UNITED STATES
NUCLEAR REGULATORY COMMISSION
WASHINGTON, D. C. 20555
September 29, 1981

D
Docket No. 50-244
LS05-81-09-074

SUBJECT: SEP TOPIC II-1.C, POTENTIAL HAZARDS DUE TO NEARBY TRANSPORTATION,
INSTITUTIONAL, INDUSTRIAL AND MILITARY FACILITIES - R. E. GINNA

R. E. GINNA
SYSTEMATIC EVALUATION PROGRAM
II-1.C, POTENTIAL HAZARDS DUE TO
NEARBY TRANSPORTATION INSTITUTIONAL INDUSTRIAL AND
MILITARY FACILITIES

FIGURE 2

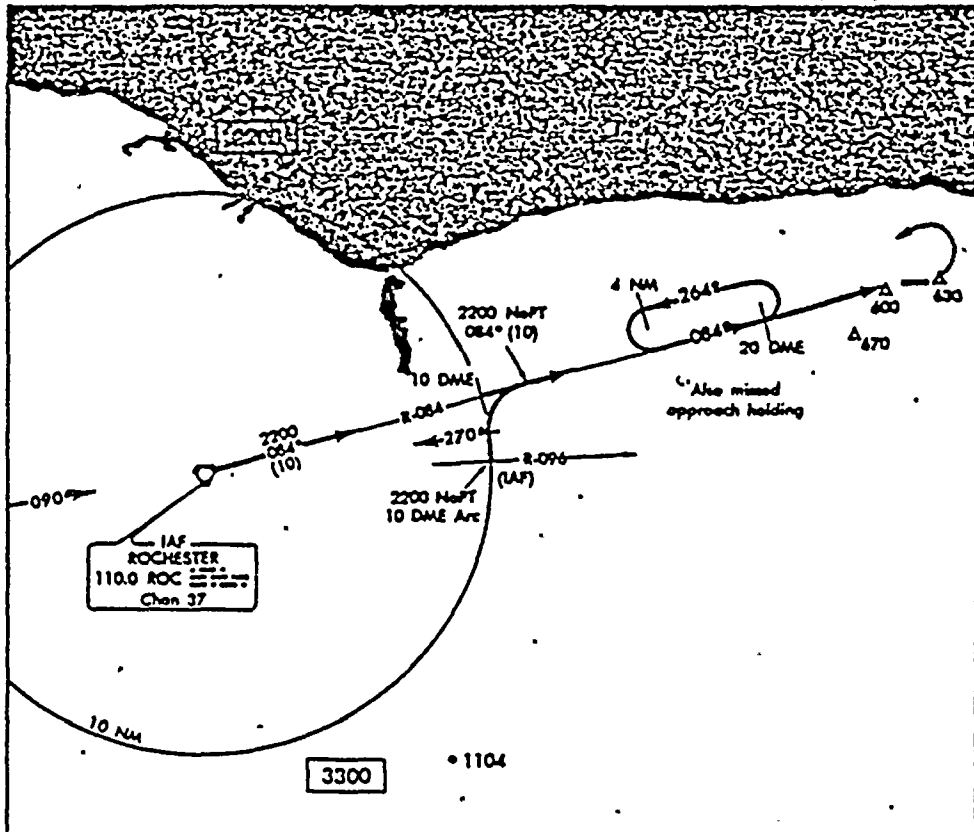
The Williamson Flying Club Airport has one paved runway. This runway, designated 10-28 and thus oriented in an almost east-west direction, is 3377 feet long and 40 feet wide. The main runway is equipped with low intensity runway lights. The airport has instrument approach capability to runway 28 from the Rochester VORTAC. Figure 2 shows the instrument flight path. There is no control tower at this airport. The airport is used for general aviation activities such as business and pleasure flying, and for agricultural spraying operations. There are currently about 5,000 operations per year at the facility, and about 30 based aircraft, including part-time based crop dusters. The great majority of the aircraft are single-engine propeller airplanes which typically weigh on the order of 1500 to 3600 pounds.⁸

R-5203

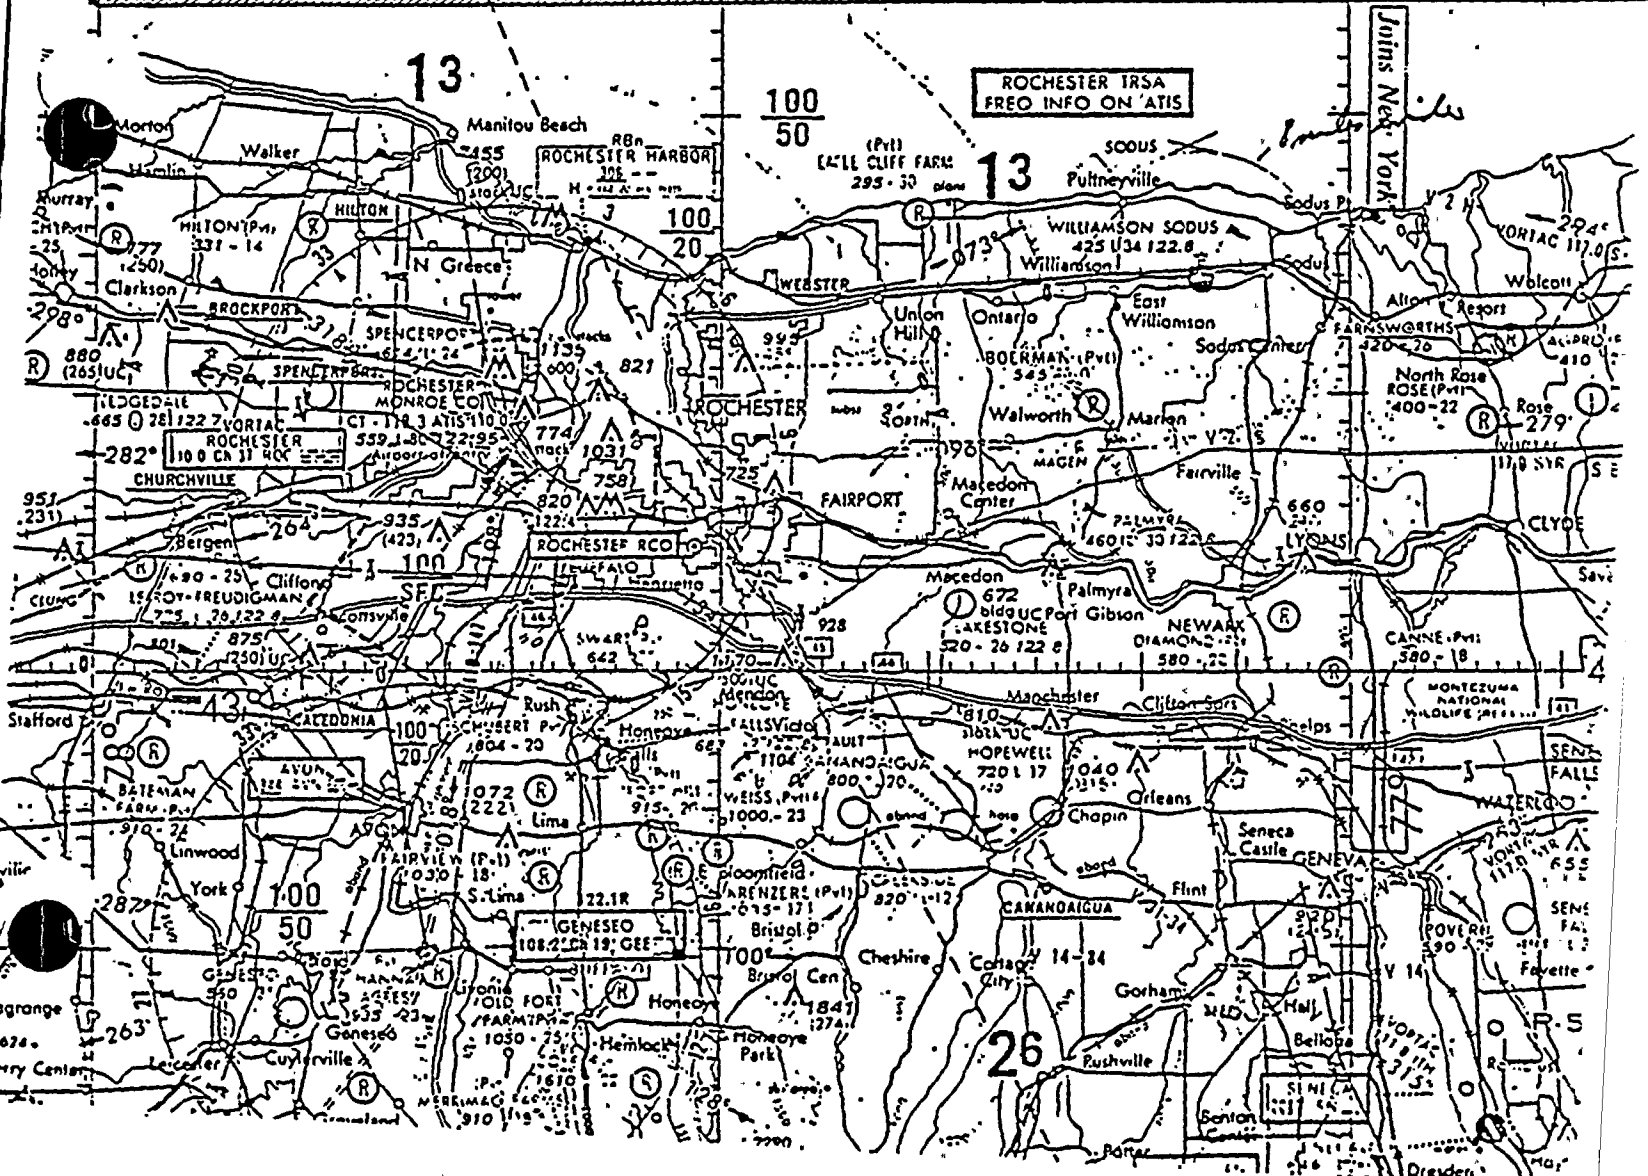
Air Force Restricted Area R-5203 is located about eight miles north of the plant site. Whenever flight activity is conducted by the Air Force within R-5203, radar surveillance is maintained by the 21st NORAD Region, the 108th Tactical Control Group, or possibly the Cleveland Air Route Traffic Control Center. Pilots rely upon on-board navigational equipment to maintain their presence within the specified limits of the restricted

area. Pilots can also be advised if their aircrafts stray beyond their limits by the radar surveillance unit covering the area at the time. The restricted area is used daily for military flight training which includes high-speed interceptor training maneuvers, operational flight checks, and air-to-air refueling. The current altitude ranges from 2,000 to 50,000 feet above the surface.⁵ A portion of the Detroit Sectional Aeronautical Chart, reproduced as Figure 3, shows the airports, air routes, and training space described above. There is also a slow-speed low altitude military training route (SR-826) which passes about 6 miles west of the plant. Acceptance criterion II.2 of SRP 3.5.1.6 states that, for military air space, a minium distance of five miles is adequate for low level training routes, except those associated with unusual activities, such as practice bombing. Air Force Restricted Area R-5203 is about eight miles from at its closest boundary, and no unusual activities such as practice bombing take place. The slow-speed low altitude military training route SR-826 is about 6 miles from the plant. Therefore, this criterion is met.

FIGURE 1

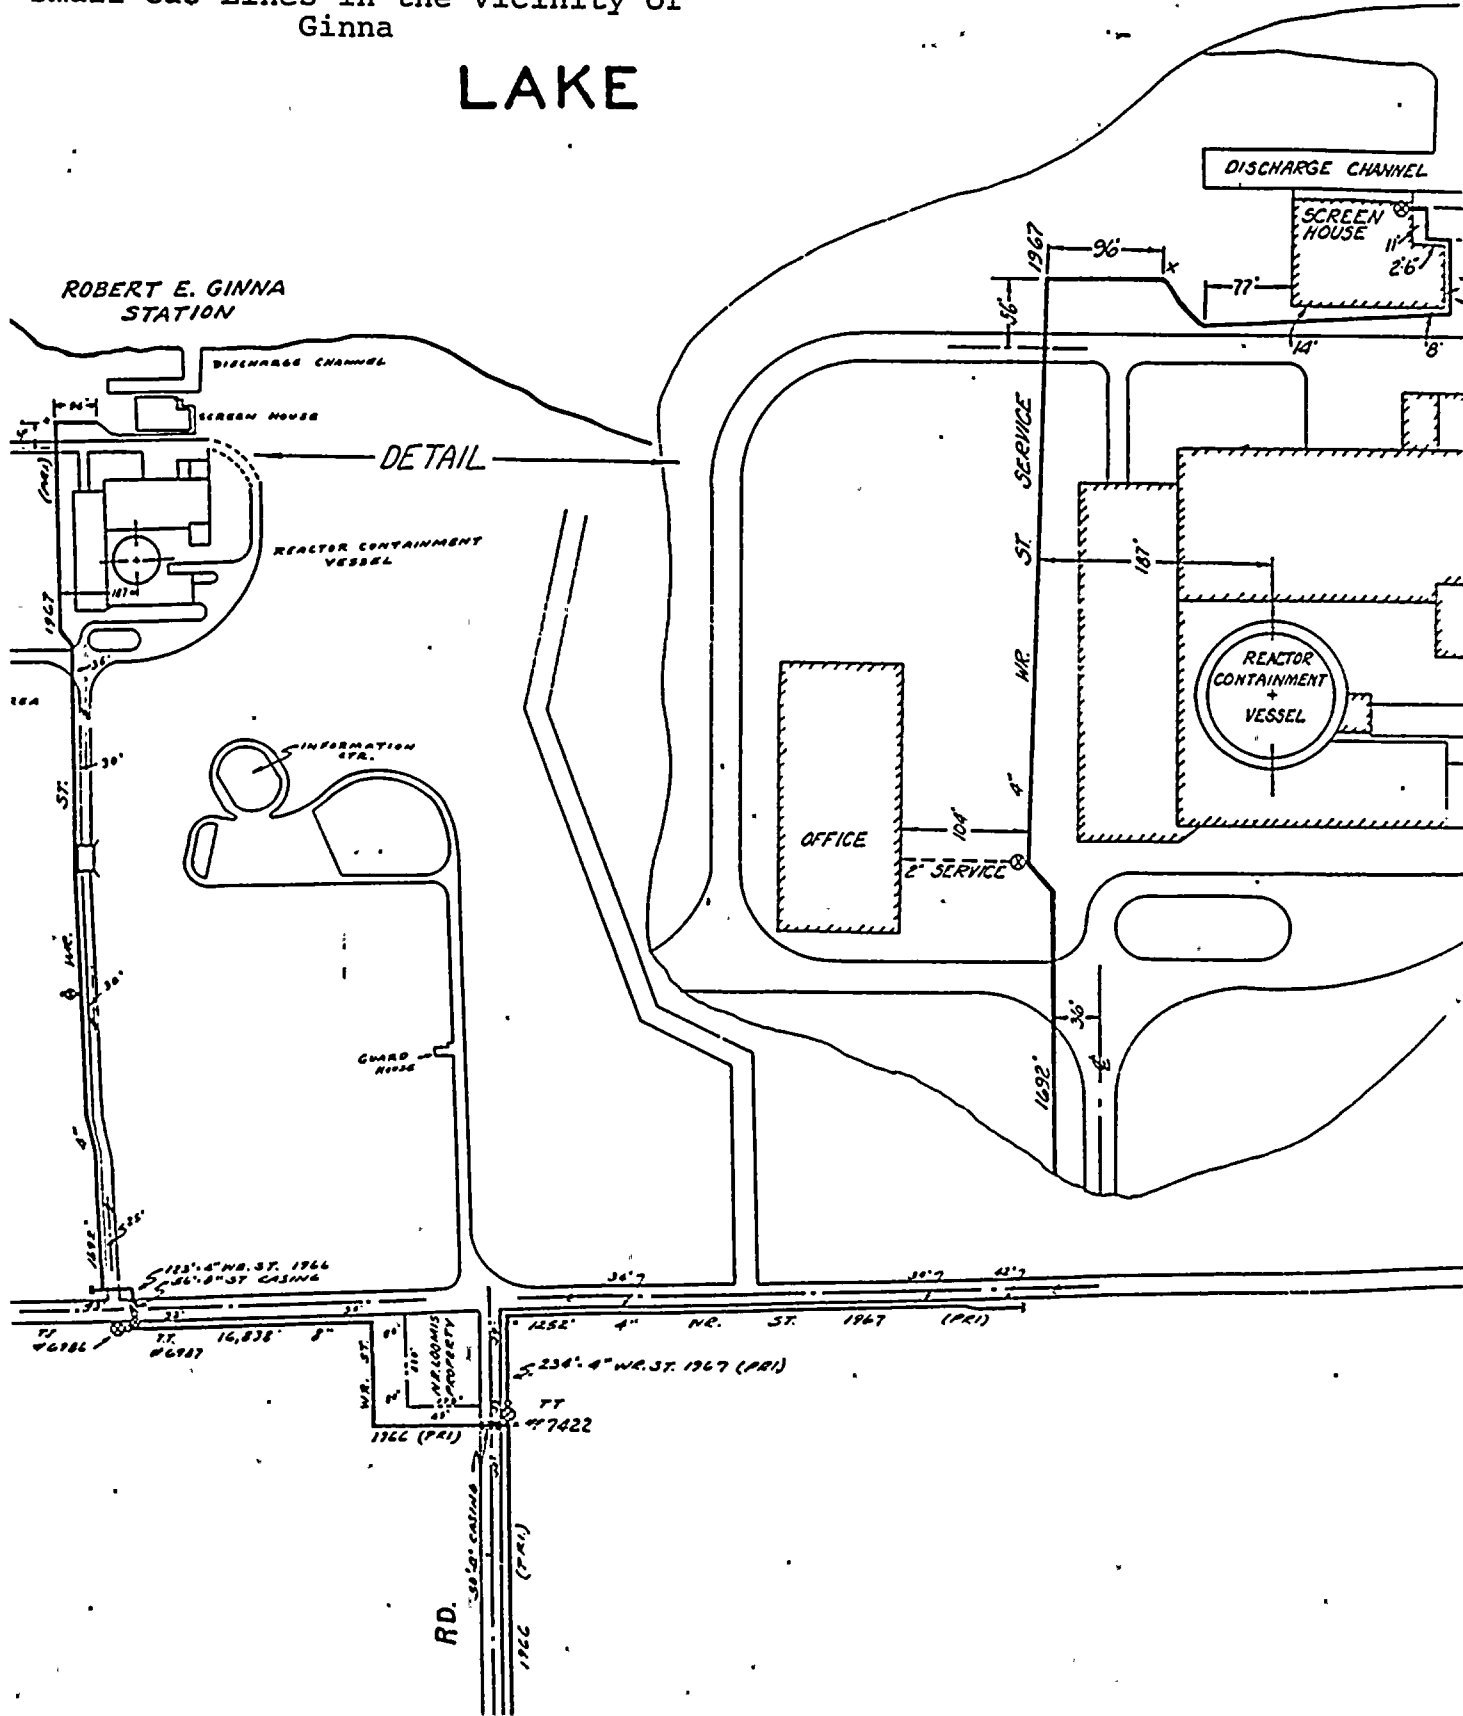
The nearest large pipelines to the plant are a 12" gas line located about six miles southwest of the plant, and a 16" gas line located about 10 miles south of the plant. These pipelines are far enough removed to assure that pipeline accidents will not affect the safety of the nuclear plant. Figure 1 shows a portion of the residential gas lines serving homes along Lake Road, as well as the house heating boiler at the Ginna plant itself. There are no gas or oil production fields, underground storage facilities, or refineries in the vicinity of the plant.

The potential effect of the gas line service to the Ginna house heating boiler was discussed during the Ginna Fire Protection review. This 4-inch gas line comes into the plant underground until it penetrates the ground surface at the east end of the greenhouse. This routing ensures separation from all other safety-related structures and systems. At this point, a metering station and a gas shutoff valve are located (the gas meter was relocated as a result of the Fire Protection review, item 3.1.13). The gas line is buried underground again after the gas meter regulator station, and enters the building through the basement wall under the house heating boiler area. The gas pipe is of welded steel construction up to the boiler. There is continuous ventilation of the areas that the gas line passes through within the building. The gas line service to the boiler and the boiler controls were reviewed and compared to NFPA-85, as requested in the staff's Fire Protection SER, dated February 14, 1979 (item

3.1.46) and was found acceptable in Supplement No. 2 to the Fire Protection SER, issued on February 6, 1981. Based on the resolution of all gas line items during the Fire Protection review, it can be concluded that no safety hazard results from the existence of the gas line on the plant site.

FIGURE 2

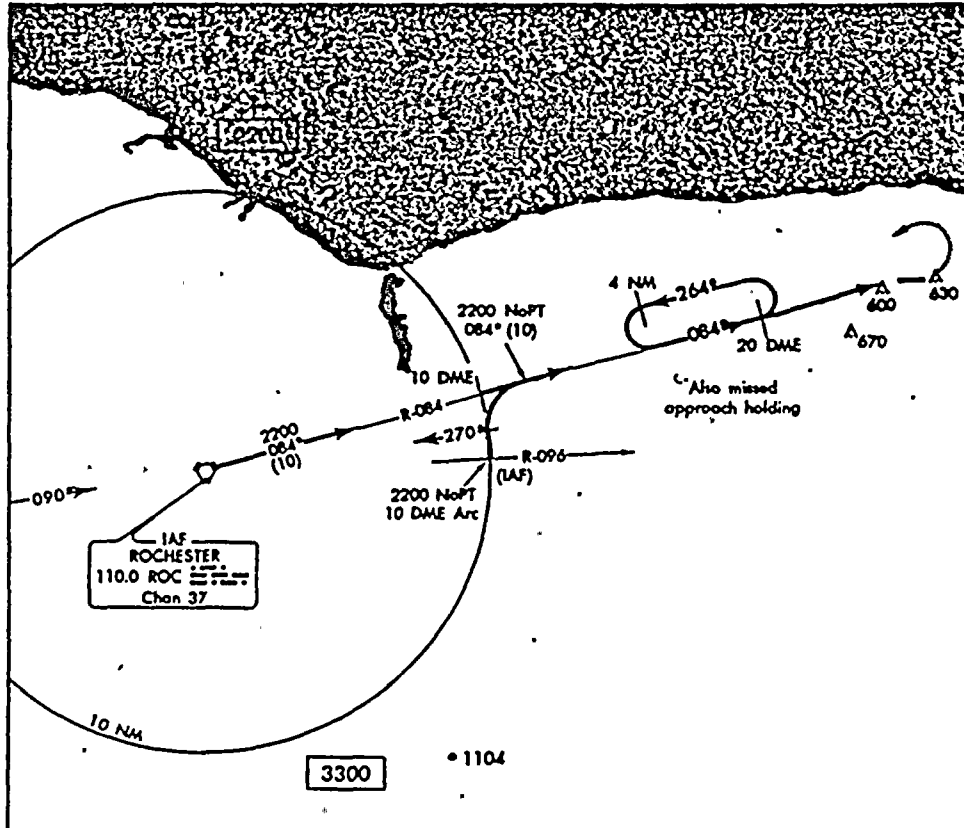
The Williamson Flying Club Airport has one paved runway. This runway, designated 10-28 and thus oriented in an almost east-west direction, is 3377 feet long and 40 feet wide. The main runway is equipped with low intensity runway lights. The airport has instrument approach capability to runway 28 from the Rochester VORTAC. Figure 2 shows the instrument flight path. There is no control tower at this airport. The airport is used for general aviation activities such as business and pleasure flying, and for agricultural spraying operations. There are currently about 5,000 operations per year at the facility, and about 30 based aircraft, including part-time based crop dusters. The great majority of the aircraft are single-engine propeller airplanes which typically weigh on the order of 1500 to 3600 pounds.⁸
